# MC baffle by HAM3, HAM2 side

**Cartoon showing that, with a tilt of only 5 degrees (3.5 in pitch and yaw), there will be regions of the baffle that are normal to light scattered from certain beam spots.**

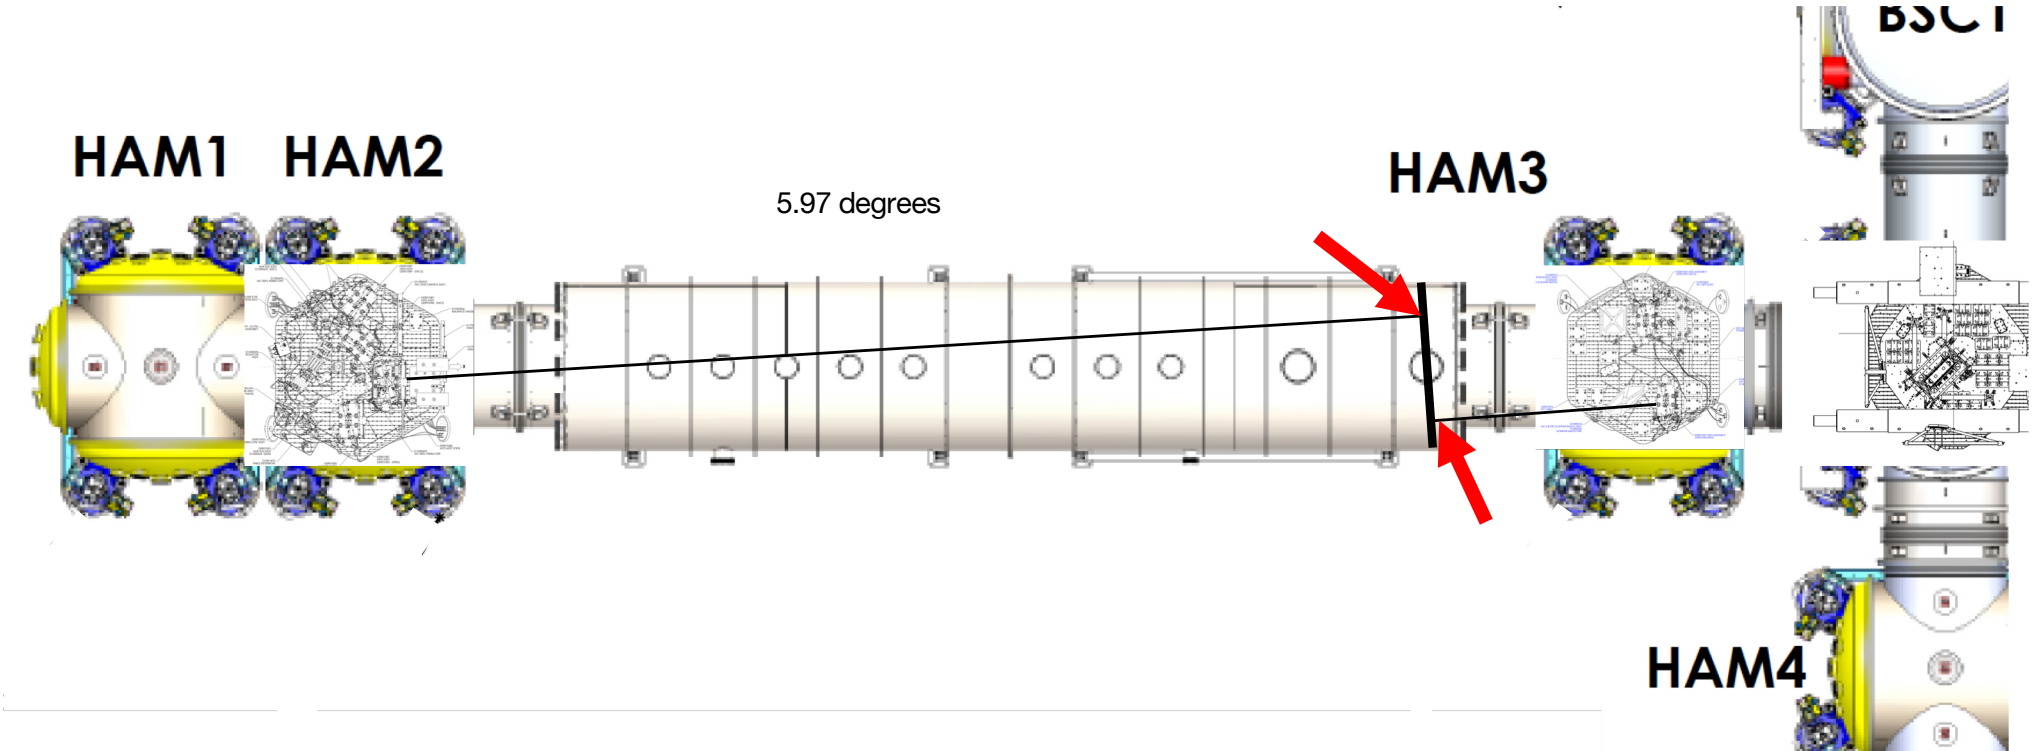
See next pages for photographs from these beam spots of the reflections from the baffles. We need to check that there are no such normal surfaces in both pitch and yaw for a new proposed angle of the baffle.

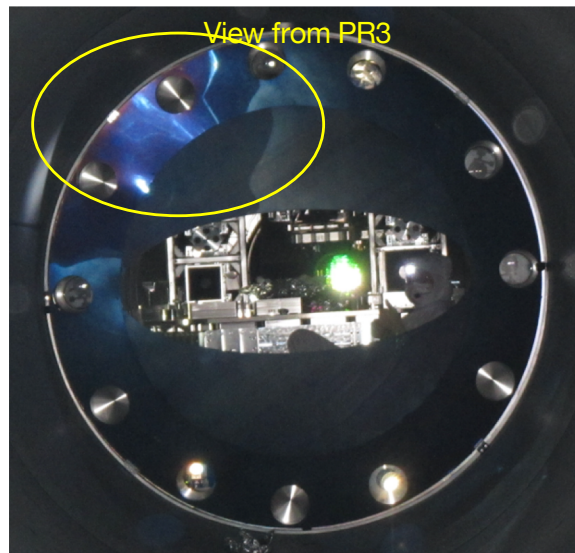
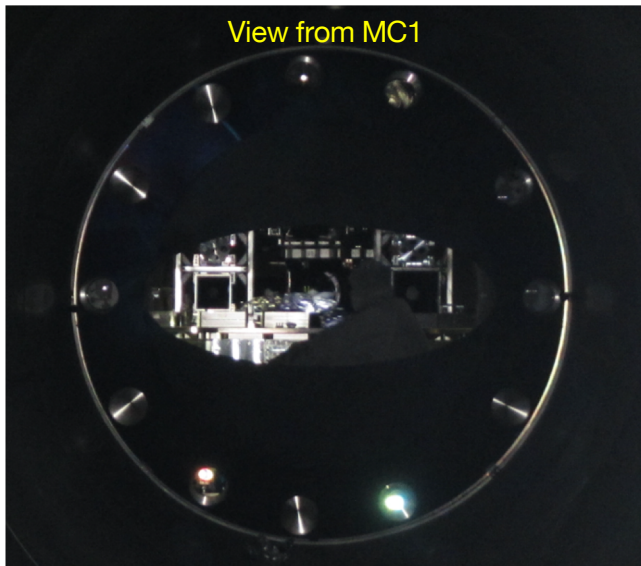
Baffle angled toward PRM

Missing view from PRM
